**BOUNTIFUL CITY**  
**PLANNING COMMISSION AGENDA**  
**Tuesday, March 21, 2017**  
**6:30 p.m.**

# Commission Staff Report

**Subject:** Public Hearing-Amendment to the Park Strip standards of the Code

**Subject:** Preliminary and Final Site Plan Review for 5 unit Multifamily Development  
**Author:** Chad Wilkinson, City Planner  
**Address:** 928 North 200 West  
**Date:** March 21, 2017

PREPARED BY: [Name] DATE: 02/11/2017  
 CHECKED BY: [Name] DATE: 02/11/2017  
 PROJECT: 1001/1004  
 DRAWING NO: C400  
 SITE PLAN

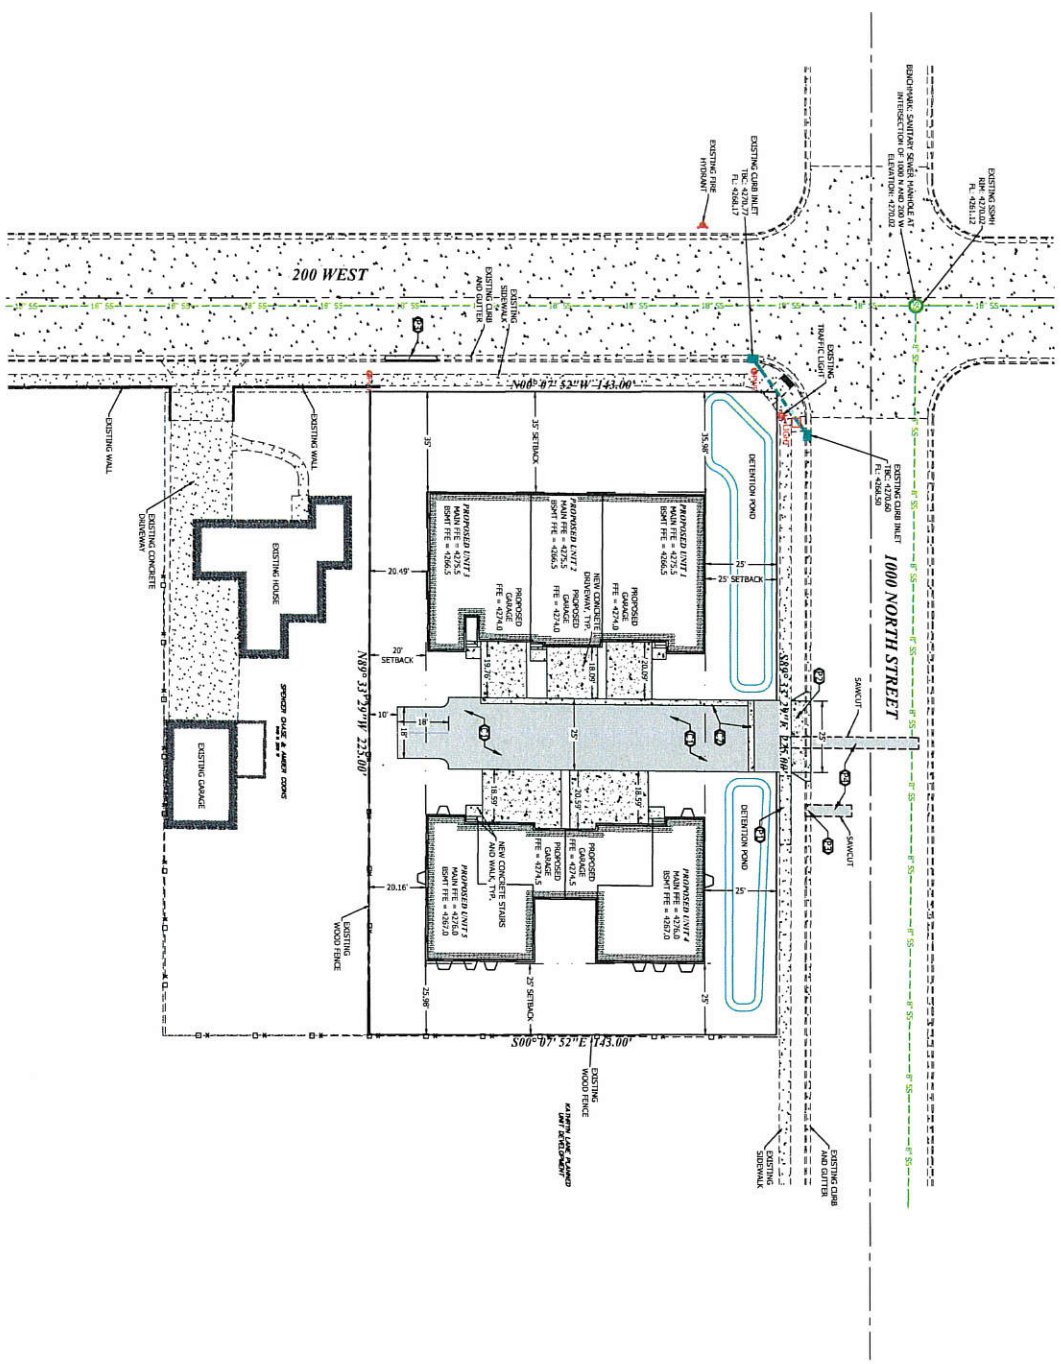
1. Complete any and all redline corrections including:
  - a. Concrete curb and gutter or edge shall be shown along all asphalt surfaces
  - b. Provide a 20 foot wide public utility easement (PUE) centered over the proposed 8 inch sewer line.
  - c. Provide a 7 foot wide PUE along the south and east property liens and a 10 foot wide PUE along the 200 W and 1000 North frontages.
  - d. Show the location and size of the existing irrigation service lateral.

**C900**  
 SITE DETAILS

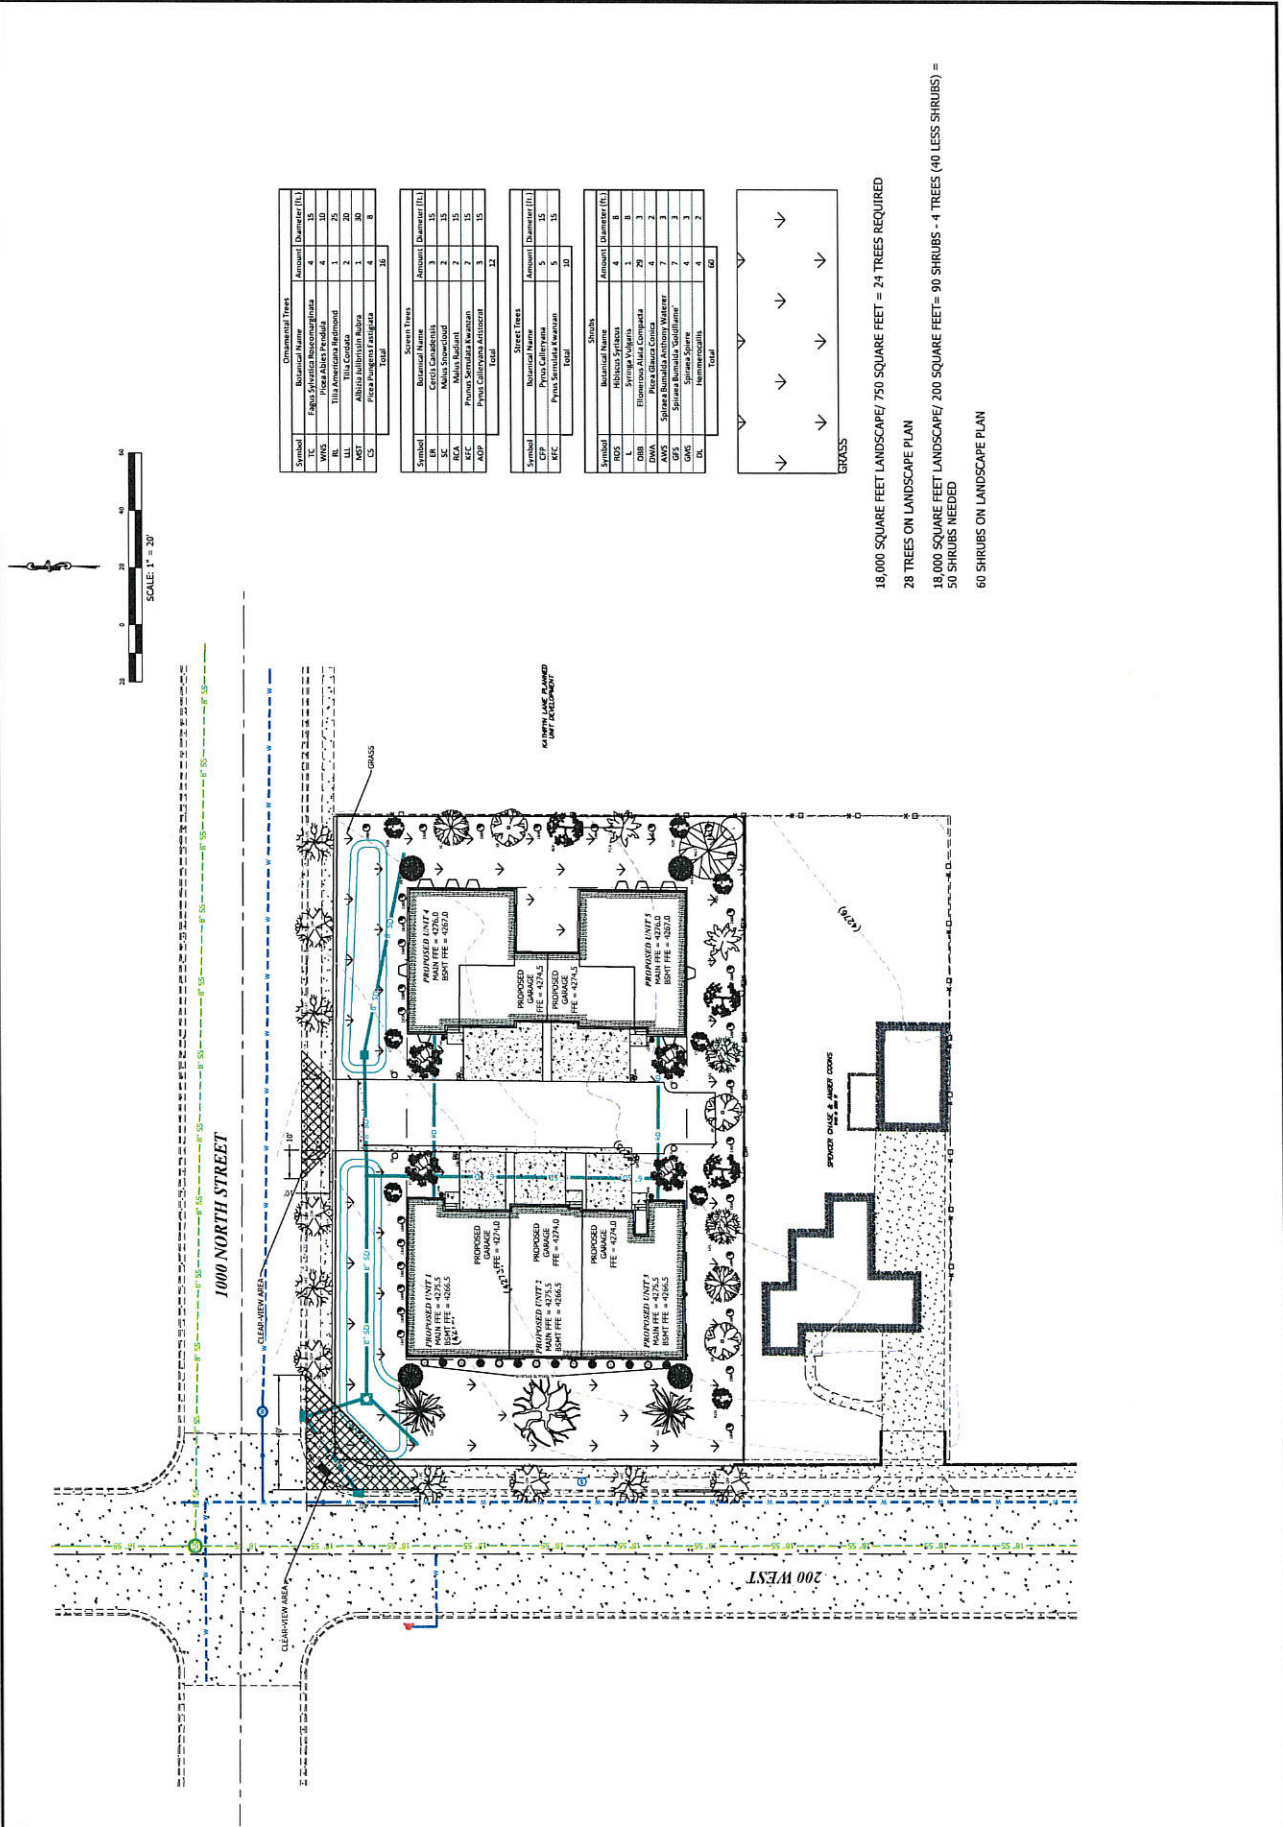
The submitted landscape plan shows the minimum 40 percent landscaping required by Code. A final landscape and irrigation plan meeting the requirements of Chapter 16 of the Land Use Ordinance and prepared by a licensed landscape architect will be required prior to building permit issuance. One of the key factors on this particular development will be maintaining the minimum front yard along 200 West and 1000 North as landscape area. This area will not be allowed to be fenced in with 6 foot fences and will need to be comprised of commonly maintained landscaped area. The applicant will need to show the required 50 square foot minimum of private fenced open space for each unit and how this

A2 | 2

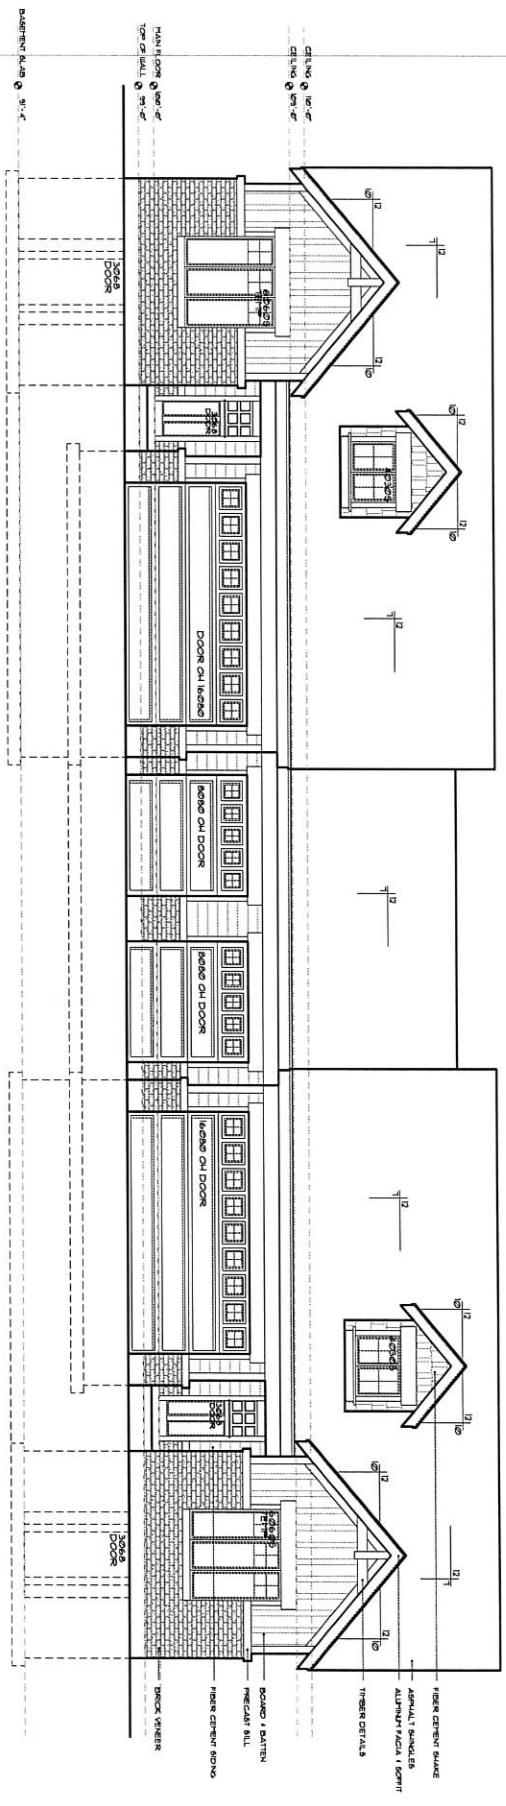
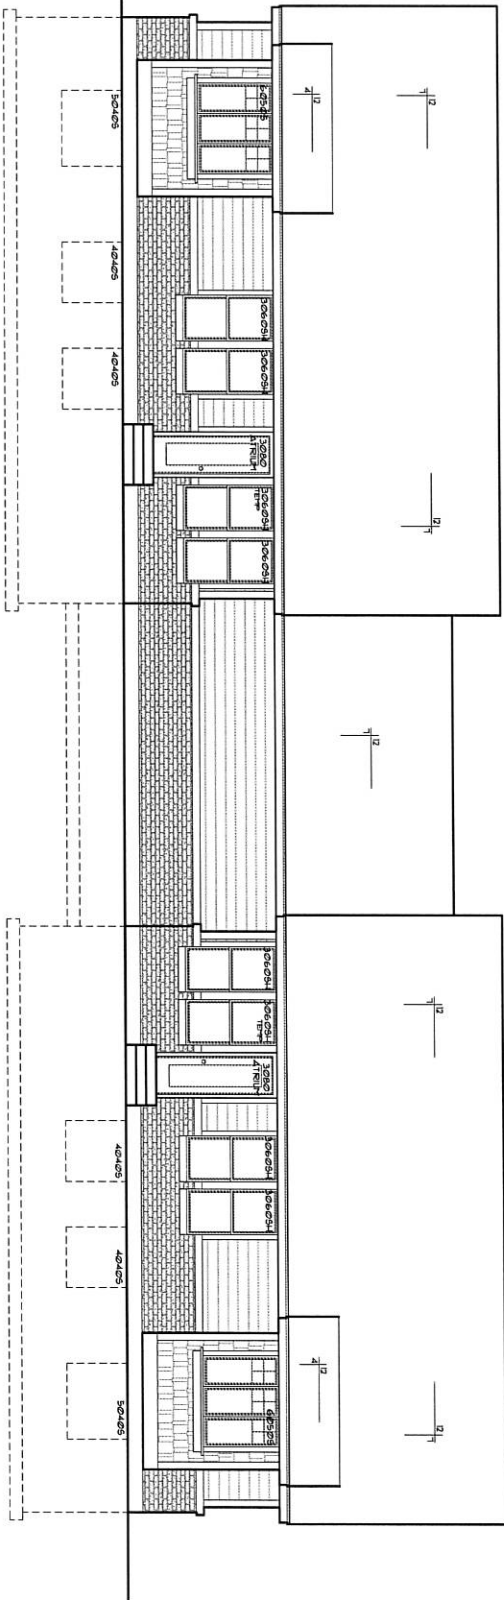
The applicant proposes a mix of brick and siding materials. The proposed elevations do not appear to meet the 50 percent minimum requirement for brick as required by Code. Elevations will need to be modified to include no more than 50 percent of siding prior to review by the City Council.

2. Prior to the item being forwarded to City Council for review, complete the following:
  - a. Revise the elevations to show a maximum of 50 percent siding materials. The remaining materials shall be brick or natural stone.
  - b. Show the locations of private fenced open space required by Code.
  - c. Any modifications required by conditions of the Planning Commission.
3. Prior to building permit, submit a final landscape plan meeting the requirements of Chapter 16 of the Bountiful City Zoning Ordinance.
4. Replace all sidewalk along the 1000 North frontage.
5. Remove and replace any and all existing damaged curb and gutter along 1000 North.
6. Pay for slurry seal of 1000 N. Street after asphalt is patched and repaired.
